Safety Recall

Subject: Fuel Pipe Bracket

Bulletin: R0020

Affected Models: 2008 NA6J (145), NB6J (165), NC6J (185)

Fig.
B

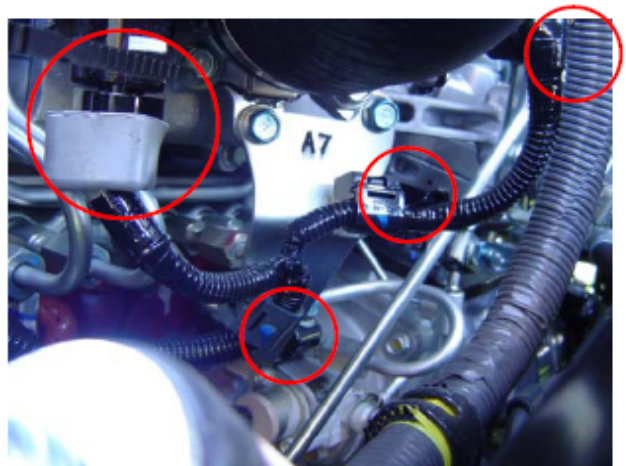
1. Disconnect negative battery cables.
2. Inspect the fuel pipe that runs from the common rail to the supply pump for clip deformation. (See figure A) If there is no deformation the pipe will **NOT** need to be replaced.

If the clip is deformed due to crushing (See figure B) the fuel pipe **MUST** be replaced during bracket installation.

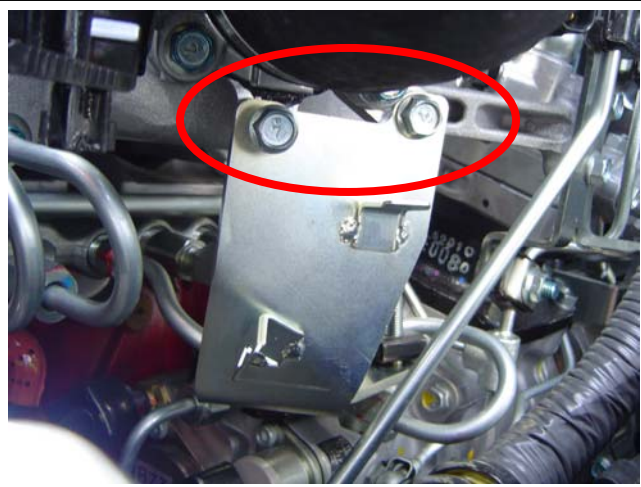
8. Install a clip on each stud of the bracket.

9. Install bracket so the fuel pipe will rest in the grooves of the clips.

10. Install two (2) bracket mounting bolts.

Note: Make sure bolts do not cross thread, intake damage may result.

Torque to 21 lbf/ft (28.5 Nm)

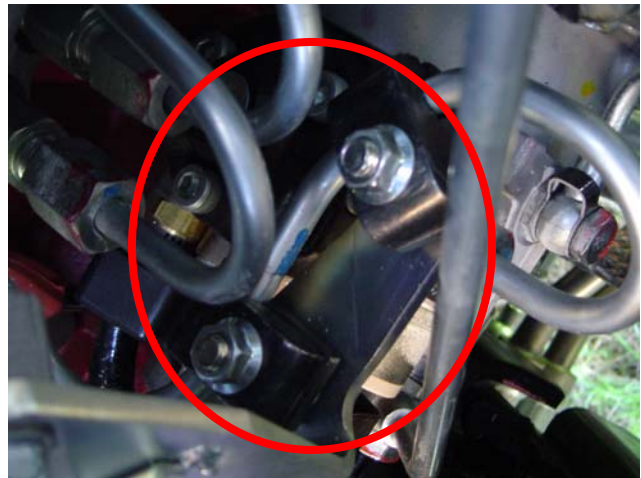
11. Install two (2) upper clips and nuts.

Torque to 30 lbf/in (3.4 Nm)
